Heart of America Northwest comments to National Academy of
Sciences, Engineering and Mathematics
Review of the Continued Analysis of Supplemental Treatment of
Low-Activity Waste at the Hanford Nuclear Reservation
on FFRDC's Second Report
Presented April 28, 2022
Representative Gerry Pollet, J.D. Executive Director

Leaking Tank B-109

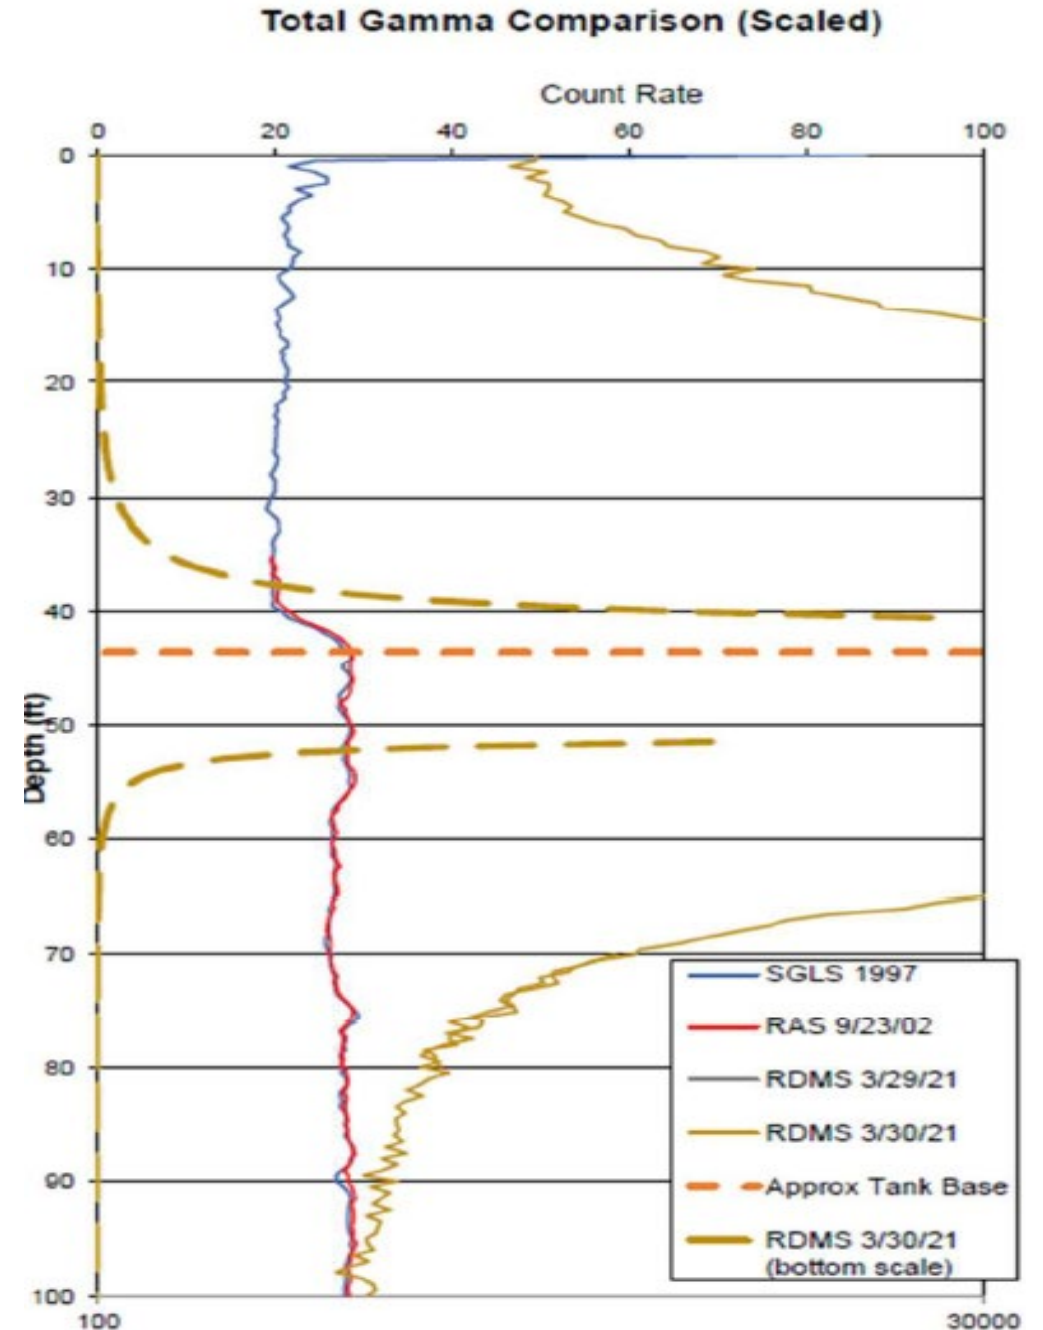
123,000 gallons of High-Level Nuclear Waste with an estimated 15,000 of pumpable liquids

- USDOE says: “no increased health or safety risk,” so NO effort to remove waste to stop the leak

- USDOE erroneously says pumping and treating groundwater after the contamination moves through the soil column will prevent any harm.

- Contamination likely to start reaching groundwater in around 25 years, and would keep contaminating it for thousands of years

The leak was evident 3 years ago.. Not one action has been taken to end the leak as required by law

- The precipitous drop in Interstitial liquid level from December 2018 to March 2019 required USDOE to report the evidence of this leak immediately to EPA & Ecology and removal of waste. Loss of 4.09 gallons / day, > 120 gallons/month.
- USDOE reported 4-29-21
- Drop in liquid level March 2016 should have triggered review if not report of suspected leak

Tank B-109 Waste Retrieval and Pretreatment

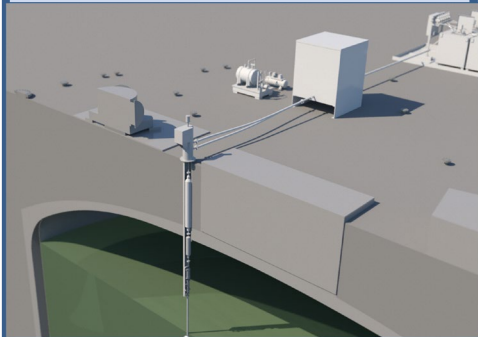
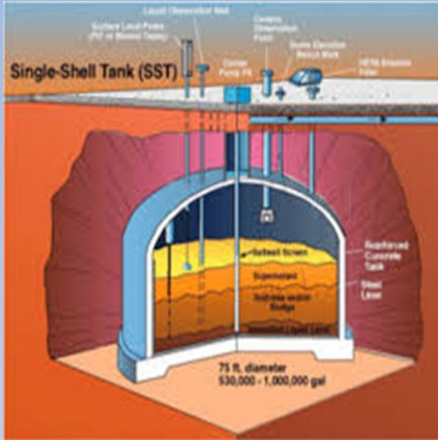
Available mobile, low cost, timely option for retrieving leakable liquids from leaking Tank B-109

- B-109 will continue to leak unless liquids are removed.
- Liquids that leak from B-109 carry high Gamma radionuclides into soil as shown in Gamma drywell monitoring at B-109 (March 2021) with peak radiation levels 41 to 51 feet below surface.
- Uses an In-Tank Pretreatment System = ITPS
- Components already developed and delivered
- Ion exchange is in the assembly put into the tank.
- Allows removal of Cesium, Strontium, TRU before waste exits tank.
- Ion exchange similar to TSCR.
- Mobile – double contained transfer lines to transport.
- Demonstrate offsite treatment to RCRA standards and use as test of TBI.
- Move to next leaking tank...
- Low cost

Easy to install system in riser of B-109 to retrieve liquids before they leak
